Stockland

28 April 2021

Stockland Submission to the Design and Place SEPP EIE

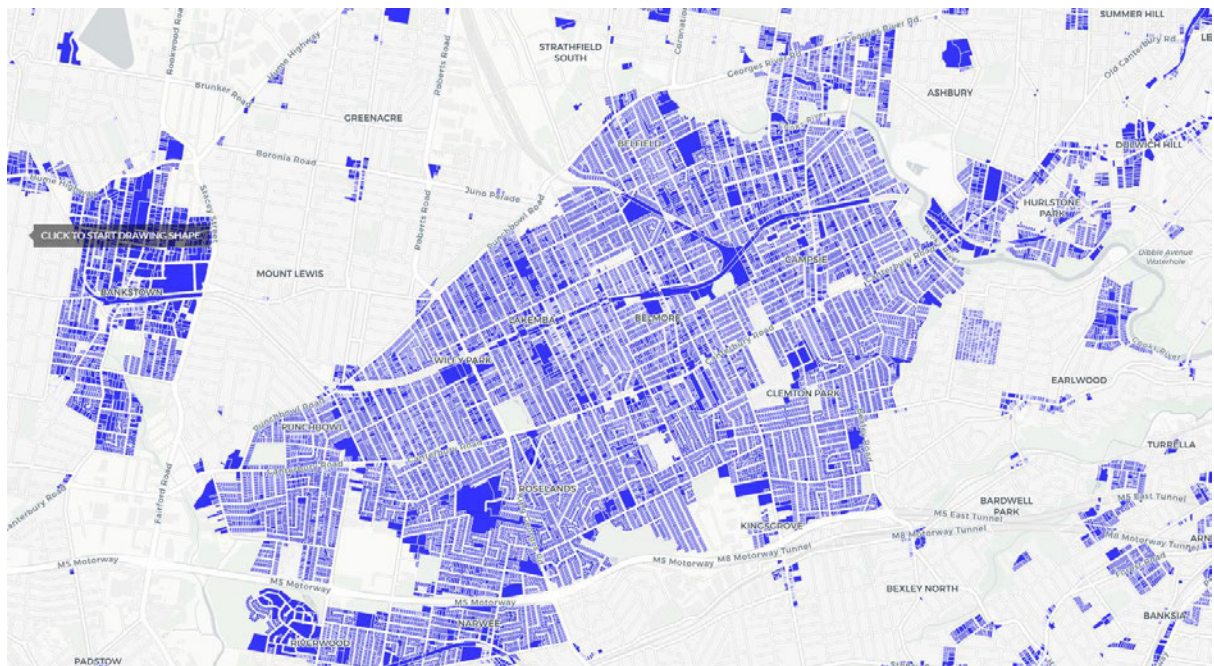
- **The areas of land in question are vast.** The following map shows all land zoned R3, R4 and B1 to B4 zones land in the Dulwich Hill to Bankstown corridor. There are 33,000 Lots with this zoning in the below area. Clearly, a proposal to require every site to provide non-residential is unrealistic and should be abandoned.
